the
**Large
 Hadron
 Collider**
 project

LHC Project Document No.
LHC-LJ-EC-0002

Engineering Change Request – Class I

New Machine Layout in IR3 and IR7

Figure 1: Sketch of the LHC secondary collimator, including dimensions.

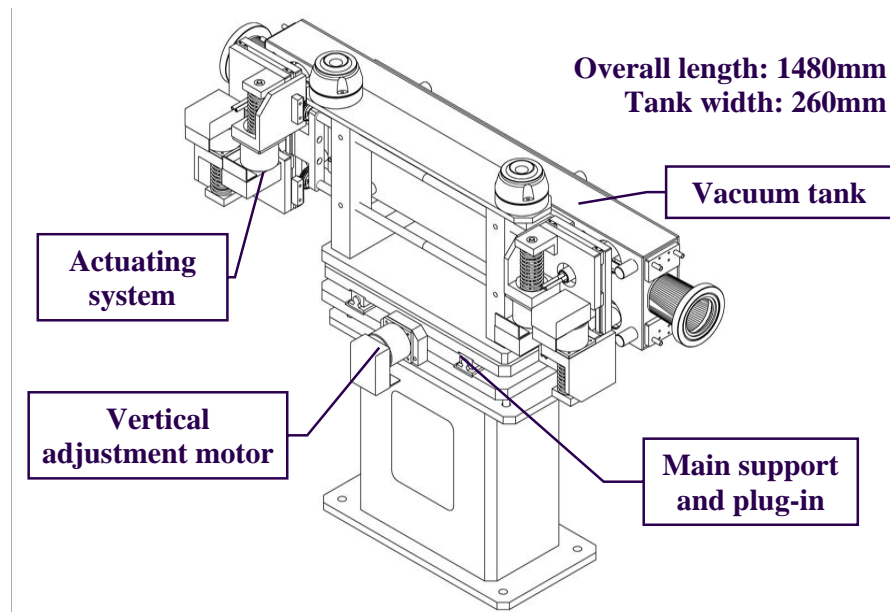
A detailed engineering design was started and the flange-to-flange length of a tank for secondary collimator was fixed to **1.480 m**.

Figure 2: Secondary collimator mechanical assembly (cross-section of a horizontal TCSG).

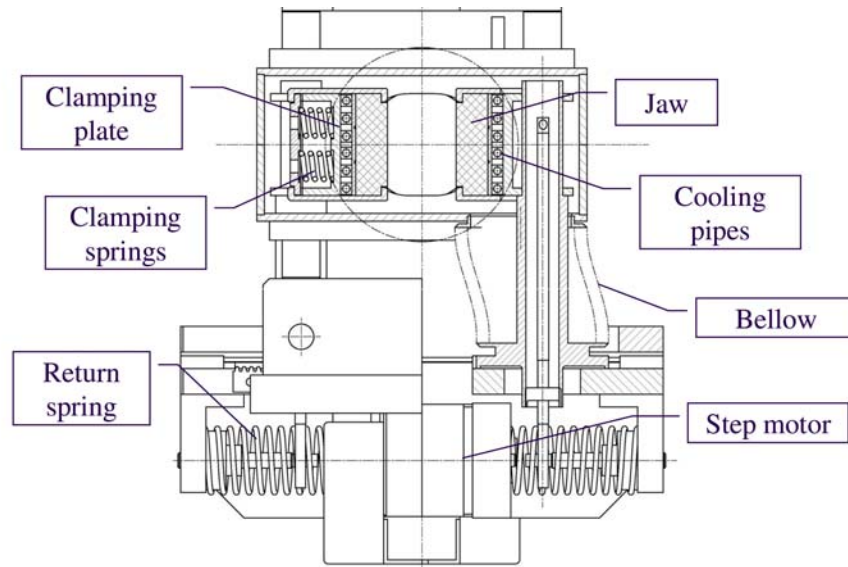
The total required length per secondary collimator (TCS) was fixed to be **2.00 m**, consistent with the detailed engineering design for a phase 1 secondary collimator (TCSG). It is assumed that the phase 2 secondary collimators (TCSM) require the same longitudinal space as the collimators for phase 1. This assumption is valid, because phase 2 collimators will have higher Z metallic materials and therefore shorter lengths than phase 1 collimators. The total length per secondary collimator then went from less than 1.0 m in the previous layout to **4.00 m** (for phase 1 and phase 2) in the new layout.

Figure 3: Predicted betatron cleaning inefficiency at injection energy. Note that a typical LHC value for a_c is 10σ .

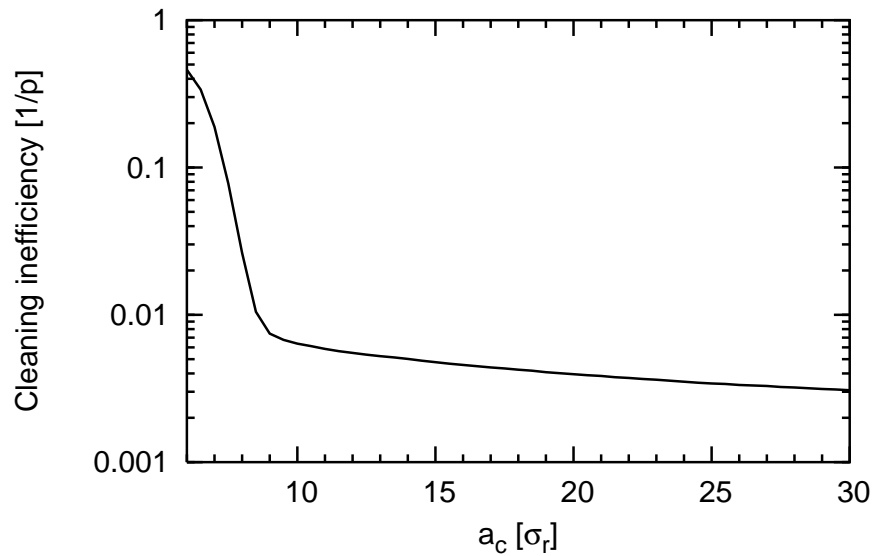
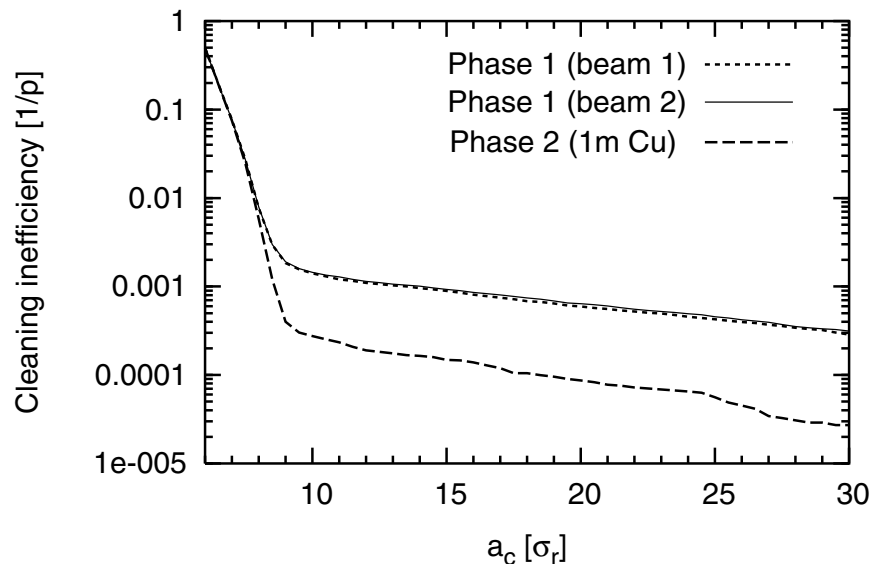
Nevertheless it is stated that the design of the collimation systems achieved quite good cleaning inefficiencies that could not be optimized further, given the LHC constraints. The predicted inefficiencies for the ideal betatron collimation at 7 TeV are about 12×10^{-4} for phase 1 and 2×10^{-4} for phase 2. Phase 1 performance is below the V6.402 performance ($\sim 5 \times 10^{-4}$), but phase 2 performance of the new system can be significantly better. The corresponding maximum amplitudes of the on-momentum secondary halo were independently estimated to be 9.3σ radially and 7.3σ and 7.4σ in the horizontal and vertical directions.
